Access Compliance Report

Public Rights-of-Way (Curb Ramps)

Intersection ID: N/A	Main Street: MATTHEWS_FARM_LN	Cross Street: WOODBINE_WALK_RD	Location: SE
ADA ID: 77808D892E8D	Ramp Type: Directional1	Initial Pass/Fail: Fail	Overall Compliance: No
Severity Score: 1.25			
Codes/Mitigation Info/Possible Solution		Field Measurements/Component Compliance

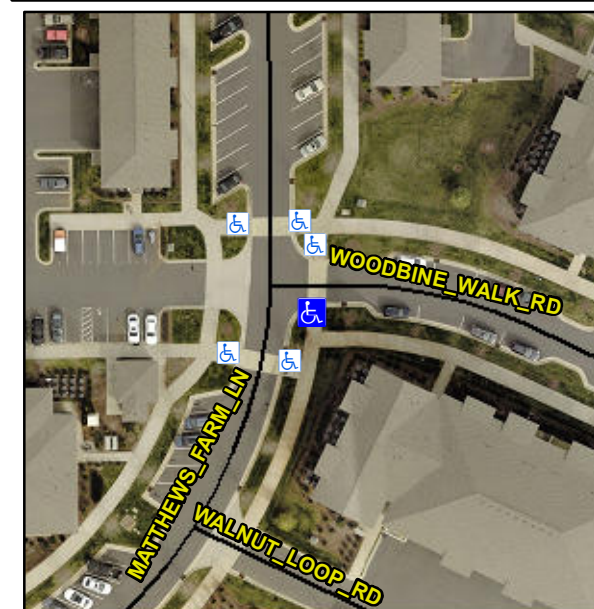
R304.5.3

Compliance	Description	Data	Compliance	Description	Data
N/A	Ramp Length (in)	77.0	N/A	Grade Break?	N/A
Yes	Ramp Width (in)	87.0	N/A	Grade Break Slope (%)	0.0
Yes	Ramp Slope (%)	5.1	N/A	Grade Break XSlope (%)	0.0
No	Ramp XSlope (%)	2.9			
N/A	Flare Type LT	N/A	N/A	Flare Type RT	N/A
N/A	Flare Slope LT (%)	N/A	N/A	Flare Slope RT (%)	0.0
N/A	Flare Traversable LT?	N/A	N/A	Flare Traversable RT?	N/A
N/A	Landing Length (in)	0.0	N/A	DWS Provided?	N/A
N/A	Landing Width (in)	0.0	N/A	DWS Contrast?	N/A
N/A	Landing Slope (%)	0.0	N/A	DWS Length (in)	N/A
N/A	Landing X Slope (%)	0.0	N/A	DWS Full Width?	N/A
N/A	Landing Curb? (Y/N)	N/A	N/A	DWS Offset LT (in)	N/A
N/A	Shared Landing?	N/A	N/A	DWS Offset RT (in)	N/A
N/A	Gutter Ponding?	0.0	N/A	Gutter Slope (%)	N/A
N/A	Gutter Lip Ht (in)	0.0	N/A	Gutter X Slope (%)	N/A
N/A	Painted X Walk1?	No		Road Slope (%)	0.3
	X Walk 1 Direction	To N		Road X Slope (%)	2.1
	X Walk 1 Width (in)	N/A		Clear Space?	N/A

X Walk 1 Slope (%)	0.3	N/A	Clear Space to XWalk (in)	N/A
	X Walk 1 X Slope (%)	2.1	N/A	Storm Grate/Utility Hazard?	N/A
N/A	Ramp inside XWalk1?	N/A		Storm Grate/Utility Type	
N/A	Any Obstructions?	N/A			N/A
	Obstruction Type		Yes	Surface Condition? (G/P)	Good
			N/A	Curb Slope (%)	4.8

Remove & Replace Entire Ramp.
